Dogger Bank South Offshore Wind Farm

**Appendix K to the Natural England Deadline 3 Submission**

**Natural England's Response to The Examining Authority's First Written Questions  
(ExQ1) and [PD-016]**

Planning Inspectorate Reference EN010125

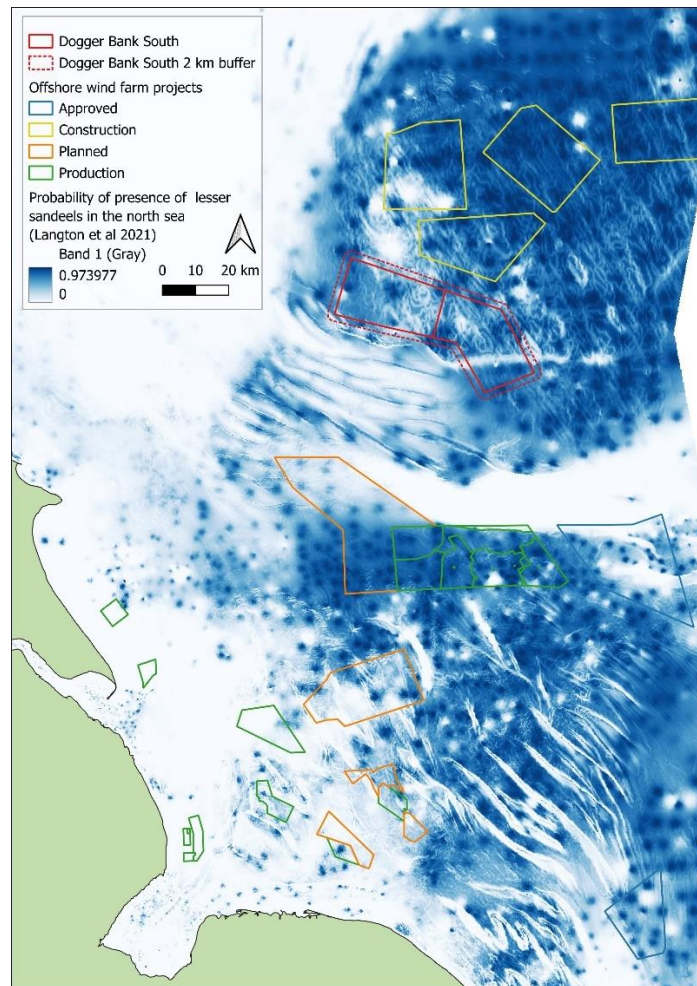
Natural England note that the vast majority of all FFC SPA guillemot (76%) and razorbill (73%) predicted to be at risk of displacement from offshore wind farms in the North Sea are at risk from wind farms in the Hornsea and Dogger Bank Zones, according to the figures presented by the Applicant in 6.1, Table 9-28 [APP-048]. We acknowledge that offshore wind arrays only make up a small percentage of the area of sea available, however, it should also be recognised that guillemot and razorbill densities are unlikely to be distributed evenly throughout the North Sea. The distribution of birds will be affected by both the location of the FFC SPA colony, particularly during the breeding season and the 'chick-rearing and moult'/'post-breeding' seasons (as evidenced in the Hornsea Four Examination), and the location of key foraging areas.

Seabirds nesting at FFC SPA are likely to be more at risk from projects within the foraging range of the SPA. Furthermore, seabirds are likely to congregate in areas where foraging opportunities are higher, such as shallow sea areas where sandeel are present. We highlight that in addition to being close to FFC SPA, Dogger Bank and the surrounding areas, including areas close to and within the Hornsea Zone, are important areas in the North Sea for sandeel (Dunn 2021, Langton 2021). This is shown clearly in Figure 1 below, and in the areas of high potential spawning habitat in Figure 2 of APP-050. It is therefore not unreasonable to expect that larger numbers of guillemot and razorbill from FFC SPA may use these areas than may be explained by assuming an equal distribution of birds throughout the North Sea. Higher impacts apportioned to FFC SPA are therefore the result of a combination of high abundances of birds recorded in the project areas and the proximity of the projects to FFC SPA.

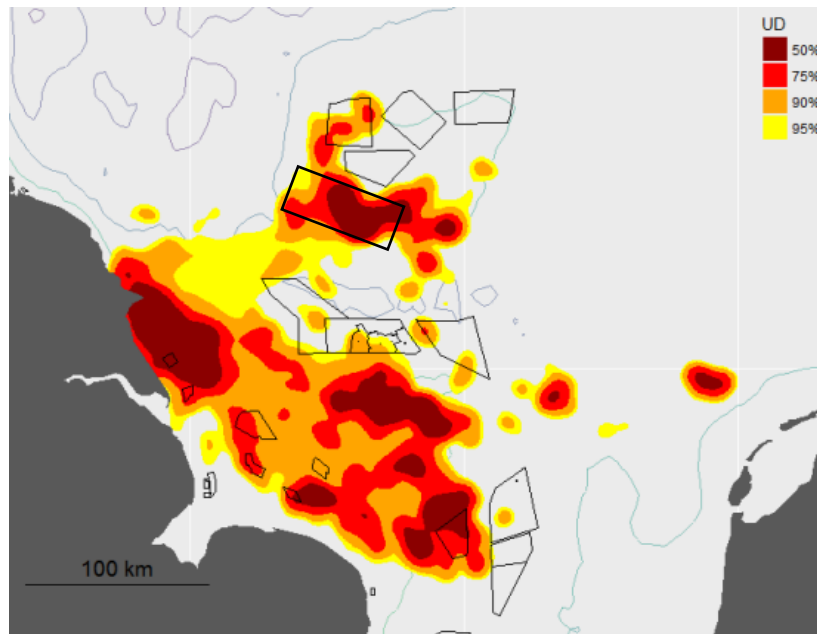
In the case of kittiwake, the standard mean maximum foraging range (plus 1SD) is 300.6km. Both Projects are therefore well within foraging range of birds breeding at FFC SPA. In addition, tracking data is also available for kittiwake breeding at FFC SPA which clearly shows that, not only is there connectivity, but that the Project areas appear to be an important foraging location for these birds. Tracking data from 2017 shows that the 50% core utilisation distribution of tracked kittiwake from FFC SPA overlaps with the Project areas (Figure 2). The 50% core utilisation distribution represents an area where, at any given time, it is expected to find 50% of a given population. We consider that the high densities of kittiwake recorded in

the Applicant's baseline surveys during the breeding season, combined with the relative proximity of the Projects to the SPA and the evidence provided by the tracking data, strongly supports our position that kittiwake using the Project areas are likely to be birds breeding at FFC SPA, and our apportioning advice reflects this.

**Figure 33:** Tracking data collected from gannet breeding at FFC SPA during the 2011 breeding season. Data collected by the RSPB Centre for Conservation Science and downloaded from the Seabird Tracking Database.

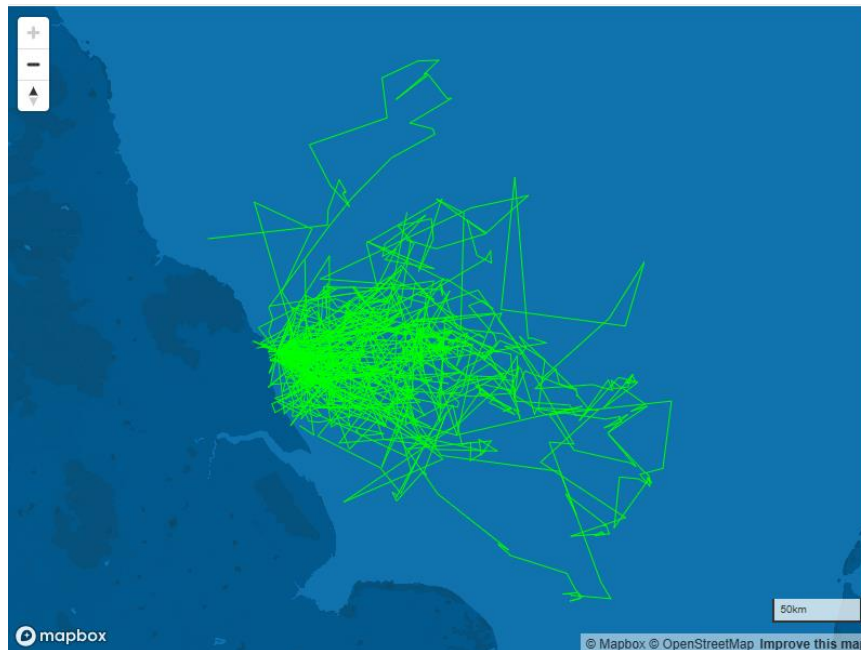
For gannet, the standard mean maximum foraging range (plus 1SD) is 509.4km which is within the foraging range of birds breeding at FFC SPA. As with kittiwake, tracking data is available for gannet breeding at FFC SPA which clearly shows use of the Project areas by these birds (Figure 3). Furthermore, tracking data has shown that gannet breeding at different colonies show colony-specific division of foraging areas (Wakefield et al 2013), reducing the likelihood that gannets breeding in Scotland use the same areas as those breeding at FFC SPA. The high densities of gannet recorded in the Applicant's baseline surveys during the breeding season, combined with the relative proximity of the Projects to the SPA and the evidence provided by the tracking data, strongly supports our position that gannet using the Project areas are likely to be birds breeding at FFC SPA, and our apportioning advice reflects this. We also note that there are high densities of gannet recorded in the Project areas during the 'autumn migration period' which may reflect larger numbers of FFC SPA birds using the area than currently apportioned using the BDMPS method. The 'autumn migration' period as currently defined (Furness 2015) includes October and November, and gannet chicks are often

still fledging from the colony in October (Butcher et al 2024). This is, therefore, potentially a source of under-precaution in the assessment for this species.
